Highgate Conservation Area Advisory Committee objection to HGY/2023/0407 for a ground floor side extension at 39 Milton Avenue, N6 5QF

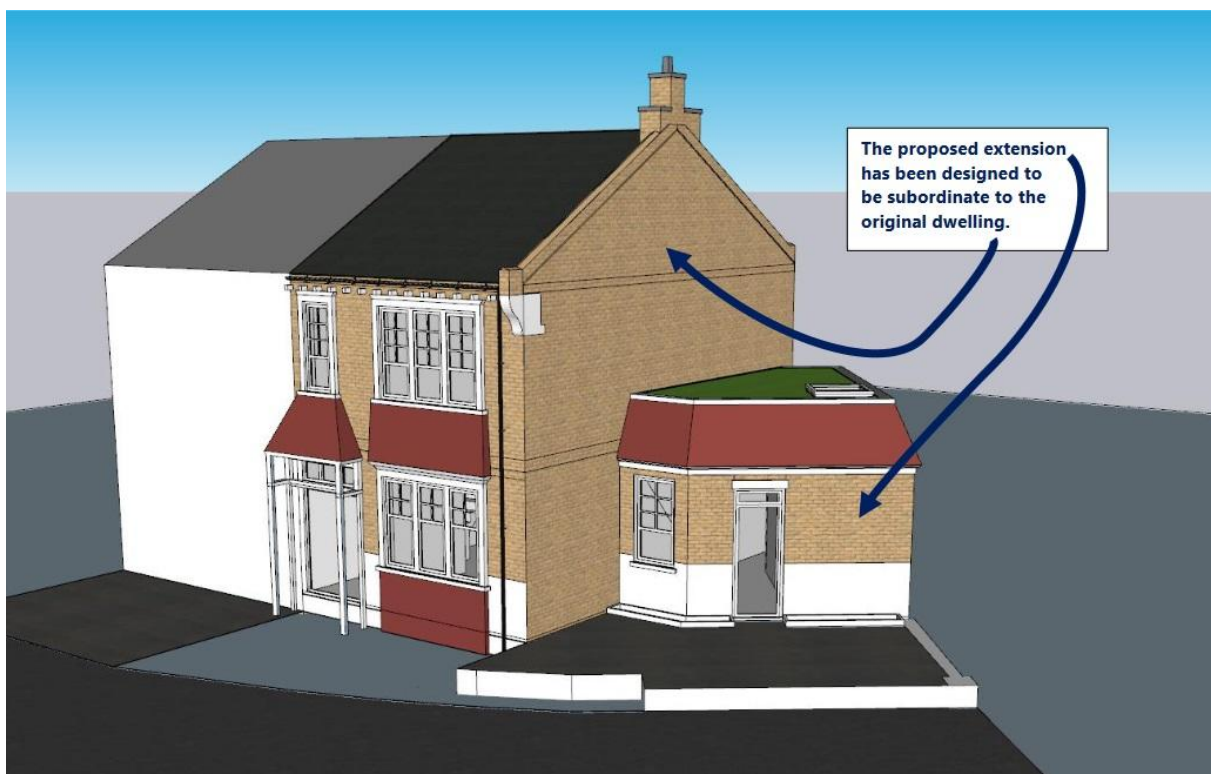
This application omits the rear roof dormer included in the previous application but retains much the same plan for the side extension. However, the roof profile of the side extension has been altered compared to HGY/2021/2200.

We believe the new extension design remains poor. The proposed roof profile is based on roof shapes at a much higher level on various nearby buildings, none of which are similar to the host building. Further, the material is altered from slate to a red material to match the colour of the panels on the front of the host property. Neither the “Design Response” document nor the elevation drawings give any sense that the red roof material will match the existing detailed tile patterns.

The result is odd and out of keeping with the area, neither being a high quality modern intervention of the type Highgate has been known for through the ages, nor in keeping with the host property. Lowering a high level feature taken from nearby quite different properties almost to ground level, then matching the colour but not the detailed pattern of a quite different feature on the front of the host building risks

producing a jarring result; the design remains “incongruous and contrived”, as the Planning Inspector said of the roof element of the previous scheme.

The application is extremely vague about what the new roof material will look like compared to the host building.

Also, we wonder why the extension window is modelled on the first floor windows of the host building, not the ground floor pattern.
